<b>JRPP No:</b>	<b>2010SYE011</b>
<b>DA No:</b>	<b>DA10/0076</b>
<b>PROPOSED DEVELOPMENT:</b>	Demolition of existing residential flat building and construction of a new residential flat building with strata subdivision 12 Ozone Street, Cronulla - Lots 1-11, SP 831 & Lots 12-13, SP 66933
<b>APPLICANT:</b>	Presflow Pty Ltd
<b>REPORT BY:</b>	Carolyn Howell, Assessment Officer Planner Sutherland Shire Council (02) 9710 0841

## Assessment Report and Recommendation

Plan showing 4/6 storey split on the subject development site

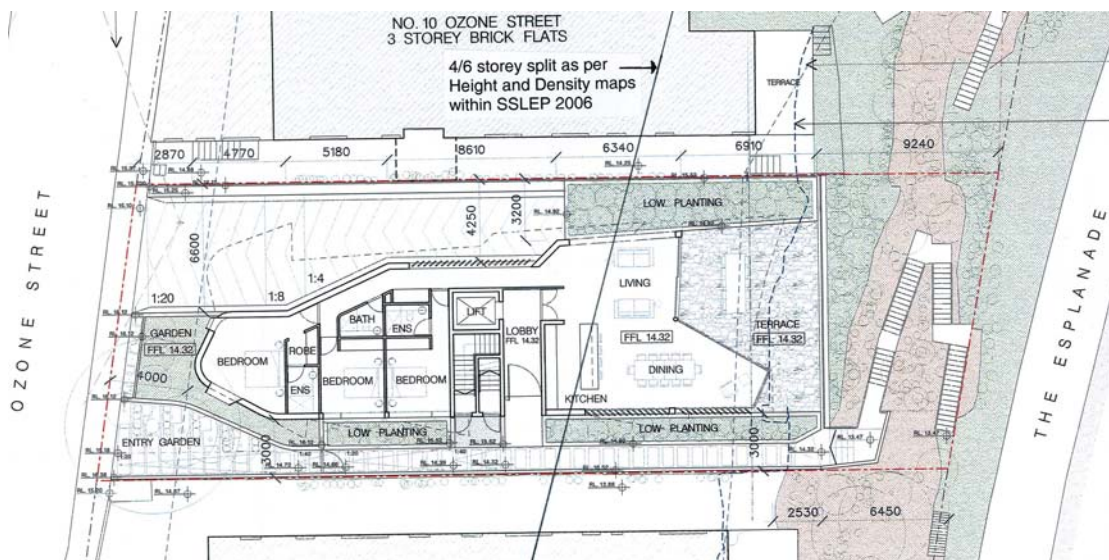
The above plan demonstrates that when the four (4) / six (6) storey split is plotted the majority of the development should be four (4) storeys in height, whereas the applicant is proposing six (6) storeys across the entire site. The rationale for the control is that the built form would be predominately four (4) storeys in height and in response to the change of levels part of a level would tuck under the building on the eastern side and one part level would be located above.

Plan showing the various interpretations of the setback control

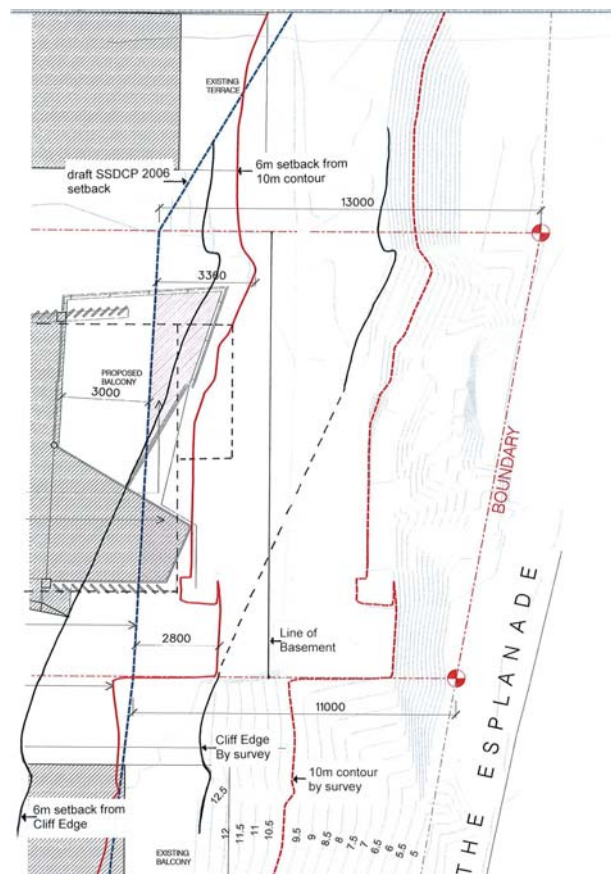
The above plan shows the setback required by SSDCP 2006, being six (6) metres from the “cliff edge”; by draft SSDCP 2006 (amendment No.6), being the line between 13 metres back from the northern boundary and 11 metres back from the southern boundary; and the applicant's proposal of six (6) metres from the surveyed ten (10) metre contour line. In addition the surveyed top of cliff and the ten (10) metre contour are shown.

It should be noted that the terrace on the subject site and the neighbouring properties shown on the above plan are provided only at ground floor level and that the proposed balconies and built form extend over all five of the upper levels with a large terrace, extending to the line of the base proposed at the ground level. The plan shows that the proposed development involves a significant breach to the current SSDCP 2006 control of a six (6) metre setback from the cliff edge, both above and below ground. It also shows that the development breaches the control within draft SSDCP 2006 (Amendment No.6), both above and below ground. The plan further demonstrates that the proposed basement breaches the applicant's own suggested setback of a six (6) metre setback from the surveyed ten (10) contour line.
